## PŘÍKAZ K ZACHOVÁNÍ LETOVÉ ZPŮSOBILOSTI

**Číslo: 2005-13-16**

**The New Piper Aircraft, Inc.**  
model PA-34

#### **Airworthiness Directives; The New Piper Aircraft, Inc. PA-34 Series Airplanes**

Figure 1.

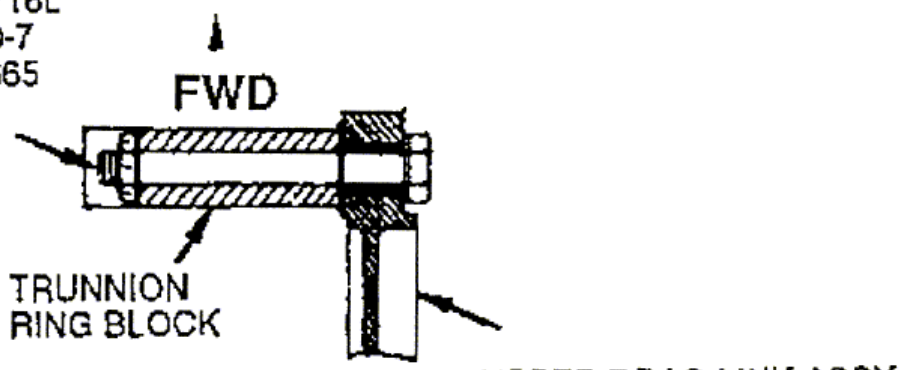
Actions	Compliance	Procedures
<p>(1) Replace the bolt and stack up that connects the upper drag link to the nose gear trunnion with new parts (or FAA-approved equivalent part numbers (P/N)) of the following:</p> <p>(i) Piper P/N 400 274 (AN7-35) bolt;</p> <p>(ii) Piper P/N 407 591 (AN960-716L) washer, as applicable;</p> <p>(iii) Piper P/N 407 568 (AN960-716);</p> <p>(iv) Piper P/N 404 396 (AN320-7) nut; and</p> <p>(v) Piper P/N 424 085 cotter pin.</p>	<p>Within the next 100 hours time-in-service (TIS) after January 28, 1994 (the effective date of AD 93-24-14), unless already done within the last 400 hours TIS before January 28, 1994 (compliance with AD 93-24-14). Repetitively replace thereafter at intervals not to exceed 500 hours TIS. Continue to repetitively replace until the actions in paragraphs (e)(2) and (e)(3) of this AD begin.</p>	<p>Follow Figure 1 of this AD.</p>
<p>(2) Do the inspections, replacements, and other corrective actions specified in Table 1 “Specified Maintenance” of Piper Service Bulletin No. 1123A, dated November 30, 2004.</p>	<p>Within the next 100 hours TIS after August 8, 2005 (the effective date of this AD), unless already done. Repetitively inspect thereafter at the intervals referenced in the Inspection Time column of the <i>INSTRUCTIONS</i> paragraph in Piper Service Bulletin No. 1123A, dated November 30, 2004.</p>	<p>Follow The New Piper Aircraft, Inc. Service Bulletin No. 1123A, dated November 30, 2004.</p>
